Different technical modifications and updatings on baby 24V

→ Starting from serial number: 13003943 dated 23/10/13 table 1009-10 R02, pos. 1 - table 1009-20 R04, pos. 27

→ Starting from serial number: 13003708 dated 17/10/13 – baby table 1012-20 R02, pos. 5 and 10

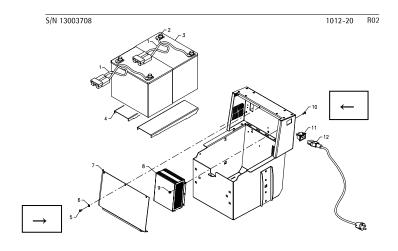
The white zinc-coated screws have been replaced with similar ones but black, already used on baby 43. These refer to the fixing screws of the electric panel and the cover of the check card relay.

Take off: pos. 5, 60140402 pos. 10, 60140402 Add: pos. 5, 60140407 pos. 10, 60140407
